# Access Compliance Report Public Rights-of-Way (Curb Ramps)

**Main Street:** EDEN\_ST **Cross Street:** ROOSEVELT\_AVE **Location:** SW

**ADA ID:** RPRK211005121547 **Ramp Type:**Type 1 - Perpendicular Diagonal Initial Pass/Fail: Fail **Overall Compliance:** No **Severity Score:** 15

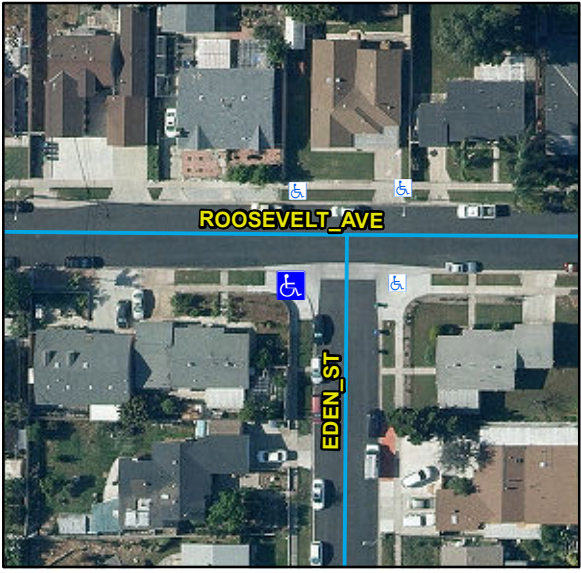
**OC Std/PROW:**  
 R304.2.2, STD 1115

Compliance	Description	Data	Compliance	Description	Data
N/A	Ramp Length (in)	78	N/A	Flare Type LT	
Yes	Ramp Width (in)	48			N/A
No	Ramp Run Slope (%)	9.6	N/A	Flare Slope LT (%)	N/A
Yes	Ramp Cross Slope (%)	1.3	N/A	Flare Traversable LT	N/A
N/A	Landing Present	N/A	N/A	Flare Type RT	
N/A	Landing Length (in)	N/A			N/A
N/A	Landing Width (in)	N/A	N/A	Flare Slope RT (%)	N/A
N/A	Landing Run Slope (%)	N/A	N/A	Flare Traversable RT	N/A
N/A	Landing Cross Slope (%)	N/A	N/A	DWS Provided	N/A
N/A	Landing Movement Obstructed?	N/A	N/A	DWS Contrast	N/A
	Landing Movement Type	N/A	N/A	DWS Length (in)	N/A
N/A	Landing Shared	N/A	N/A	DWS Full Width	N/A
N/A	Clear Space	Yes	N/A	DWS Offset Left (in)	N/A
N/A	Clear Space To Crosswalk (in)	N/A	N/A	DWS Offset Right (in)	N/A
N/A	Marked Crosswalk 1	No	N/A	Marked Crosswalk 2	No
	Crossing 1 Direction	E		Crossing 2 Direction	N
	Marked Crosswalk 1 Width (in)	N/A		Marked Crosswalk 2 Width (in)	N/A

**Possible Solutions:**  
**Remove & Replace Curb Ramp With Two New Directional Ramps or Equivalent.**
